**RE: RESPONSE TO INFORMATION REQUEST (RAL/2025/5992)
 SECTION 13.2 OF THE DEVELOPMENT ASSESSMENT RULES
 MERINGANDAN ROAD, MERINGANDAN QUEENSLAND 4352**

- Development Permit for Reconfiguration a Lot – Two (2) Lots into 199 Lots and Two (2) Balance Lots in Five (5) Stages.

Figure 1: Lodged Plans

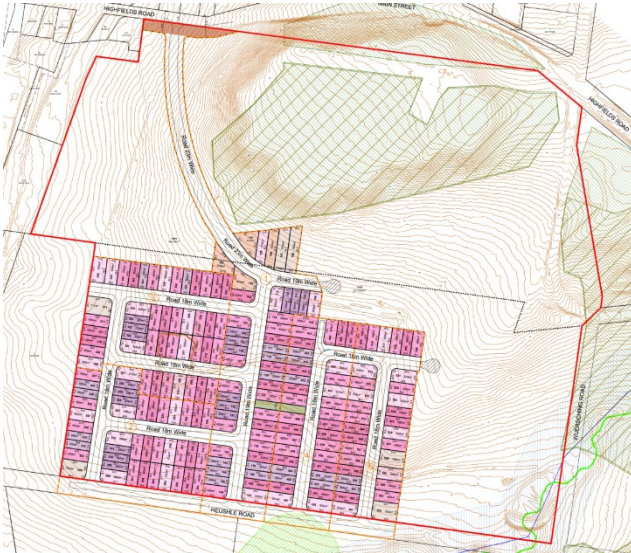
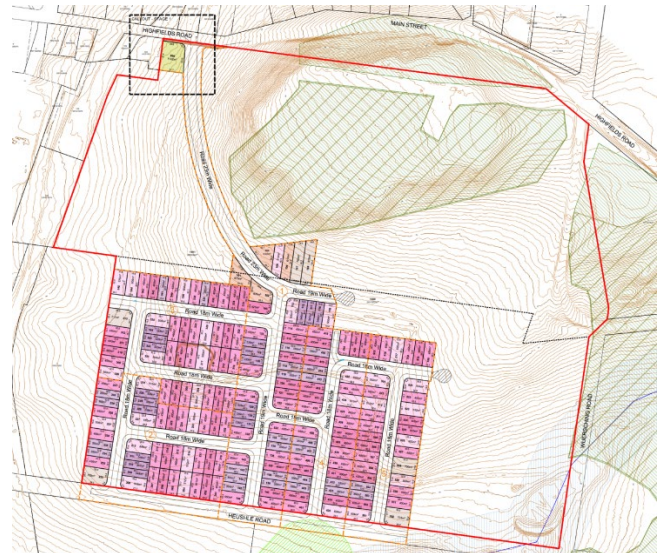
In response to the request, and as further detailed below, we note that the proposed development has been amended as follows:

1. Adjustment to the Stage 1 boundary to incorporate a basin;
2. Reduction to road dedication along Main Street;

3. Removal of the previously mapped State waterway ('waterway barriers work - low risk');
4. Inclusion of an 18m wide road between Stage 1 and 4;
5. Inclusion of bin pads for specific lots; and
6. Minor changes to lot sizes and frontages to accommodate the above changes.
